ON INSTALLATION OF THE SIDE SPAN TONGUE SPRING IT WAS DISCOVERED THAT THE FIXINGS CANNOT BE INSTALLED AS PER DRAWING, DUE TO A CLASH WITH THE RADIUS GIRDERS. THIS IS ILLUSTRATED IN THE PHOTOS.

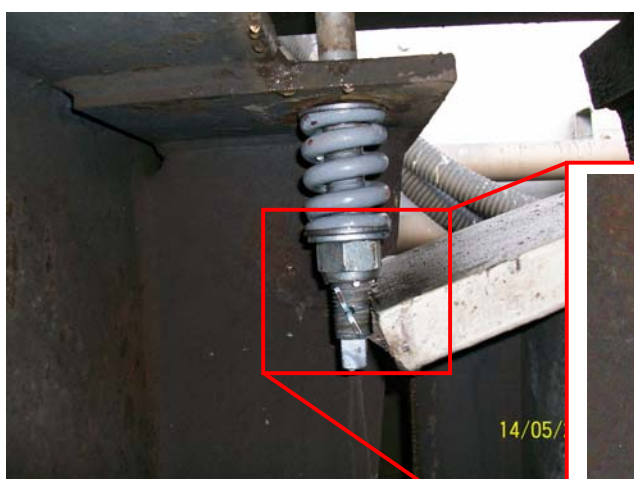
IF SECOND NUT IS TO BE INSTALLED TO DRAWING MODIFICATION TO RADIUS GIRDER WILL BE REQUIRED.

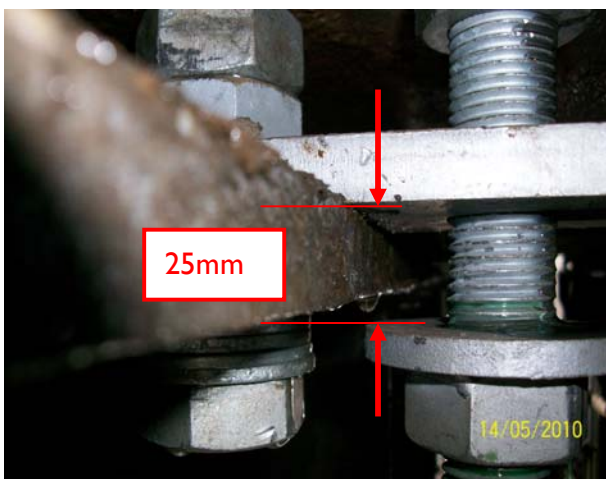
THE SIDE SPAN ROCKER LINK
PLATE TO SUPPORT BEAM IS NOT
FITTED TO DRAWING.
LINK PLATES HAVE BEEN REEMED
OUT TO ALLOW FOR ALIGNMENT
WITH ROCKER PLATE HOLE.
ALSO THE SPECIFIED 15mm
CLEARANCE BETWEEN LINK PLATE
AND WASHER IS NOW 25mm DUE
TO CLASH WITH BEAM FLANGE.

SEE BOTTOM PHOTOGRAPH.
